Engineering Note

14875-TUL-XX-XX-RP-S-90001

64 Folders Lane - Burgess Hill

Re: DM/25/1679 64 Folders Lane, Burgess Hill, West Sussex / Surface Water Pumped Solution

Engineering Layout

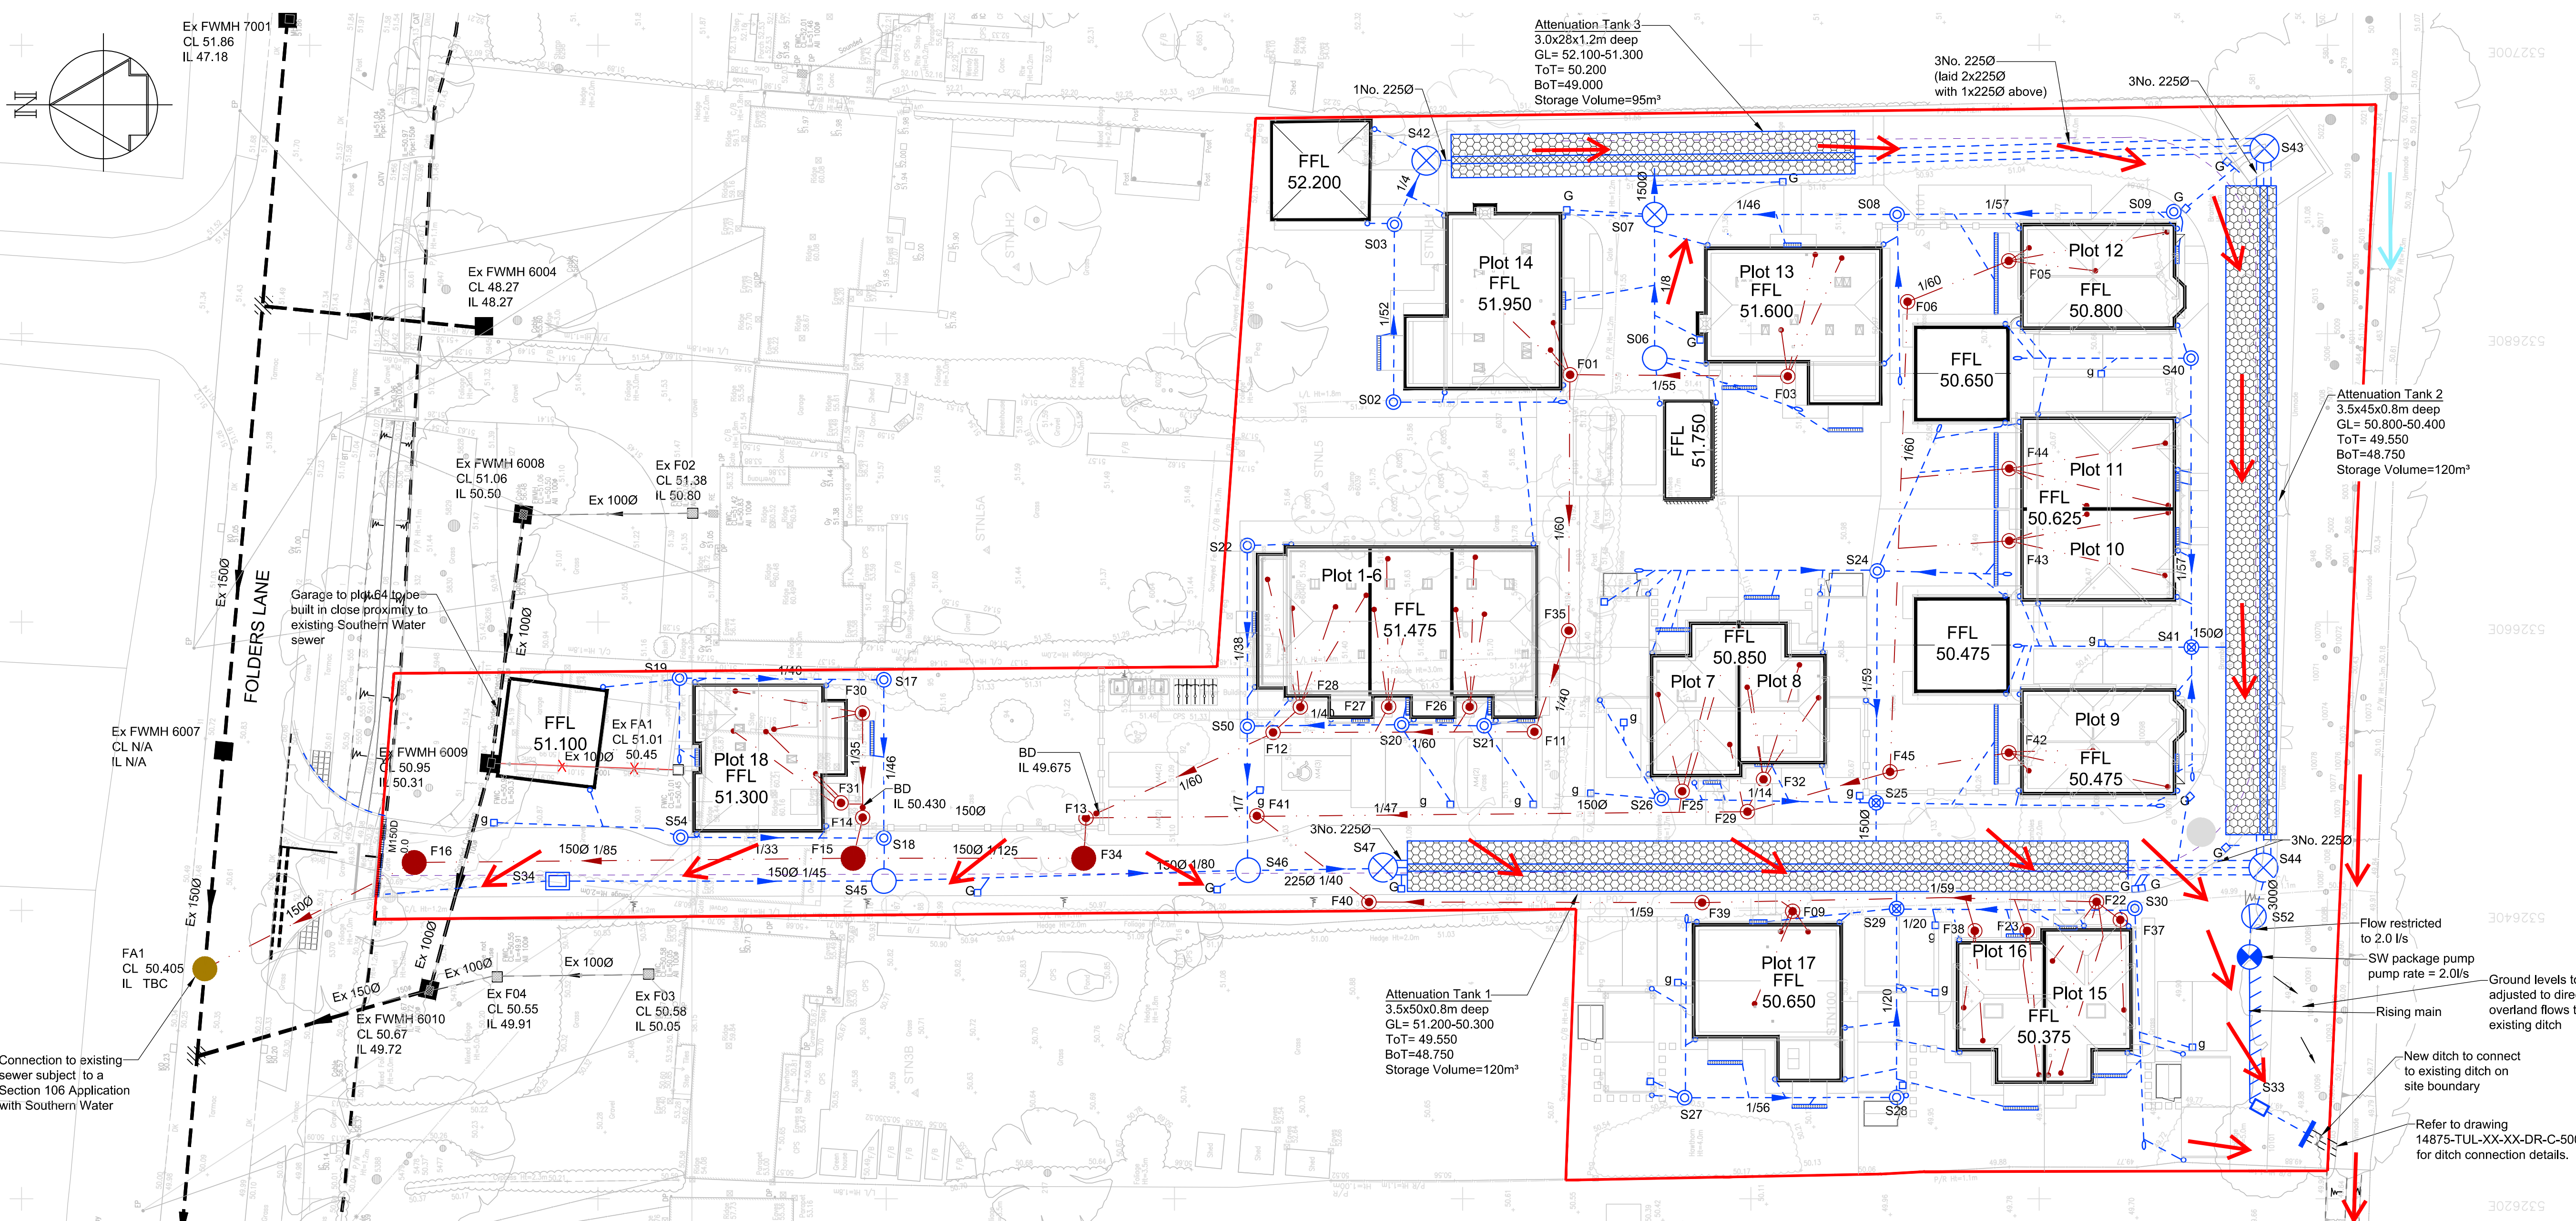
1. A full impact assessment of a pumped system failure.
2. Details of emergency procedures to accommodate 24 hours of water storage in such an event.
3. A clear proposal for connecting to the ditch through appropriate ground contouring and reinstating a functional ditch profile.

In the event of both pumps failing, the pump chamber and outfall ditch are located at the low end of the site, and the ground levels are such that any overground flooding would initially travel down the access road to the southern end of the site before naturally flowing to the new outfall ditch in the south western corner. Beyond the new ditch, ground levels naturally continue to fall to the southwest, away from the development and along the alignment of the existing ditch. As a result, there is a fail-safe system in place in the event of a total pump failure.

Plots 15 & 16 are closest to the pumpstation and have the lowest ground floor level on the site which is set at 50.375m AOD. The ground levels adjacent to the surface water outfall in the southwestern corner of the site are typically at 49.9m AOD, with the new ditch levels approximately 500mm lower. Consequently, the ground floor of the adjacent unit is some 475mm above the top of ditch level which will provide protection from overland flows.

A mark-up of the Engineering Layout drawing is attached which indicates the overland flow routes in the event of a total failure of the pumpstation. Details of the installed pumpstation are also attached.

Indicates overland flood route in the event of a total failure of the pumpstation.
